## **Durita, Colorado, Disposal Site Inspection Report, May 22, 2008**

Participants: Dave Holland, Hecla Mining Co; Earl Reams, Reams Construction; Edgar Ethington, CDPHE; Tracy Ribeiro, DOE; Cheri Bahrke, Stoller; Marilyn Kastens, Stoller; Mike Widdop, Stoller

*Northwest corner of site showing fence encroachment; looking east, visitor standing at boundary monument.*

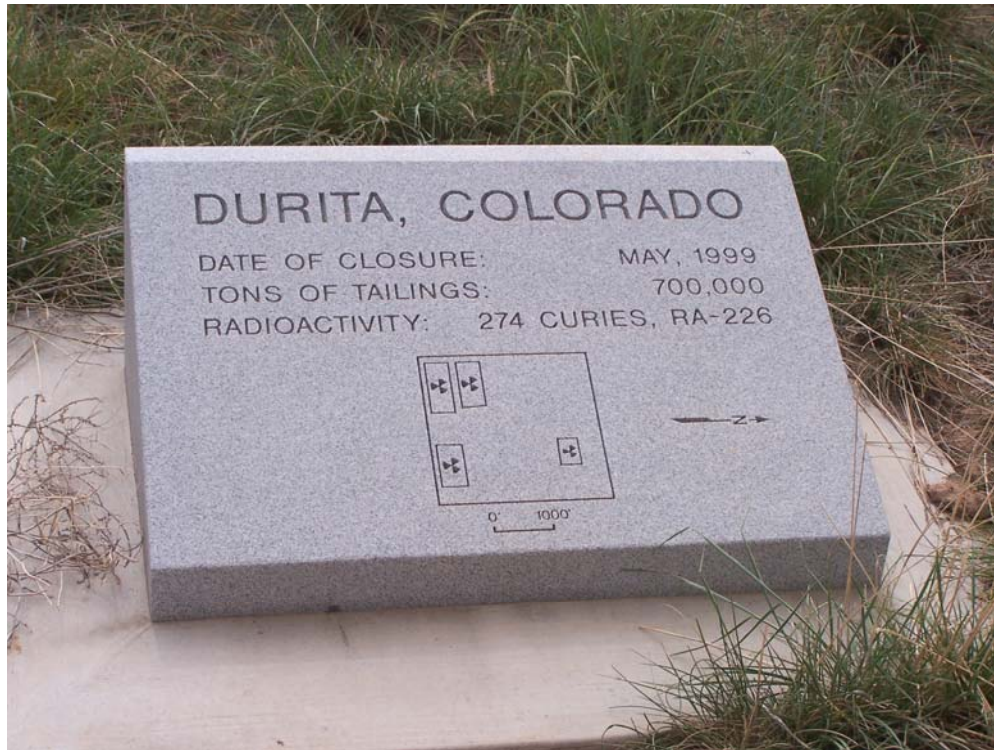
Fencing has been installed outside the site boundary on the west and north sides of the site. At the northwest corner, the encroachment appears to be 17 feet onto the private property to the west and 36 feet onto BLM property to the north, based on the location of the survey monument. The licensee must resolve this issue before transition.

8. The licensee must resolve the issue of fence encroachment.
9. Debris, mostly tumbleweeds, accumulates against the fence in places. Removal may be necessary if the debris interferes with drainage and this item will be added to the inspection checklist.
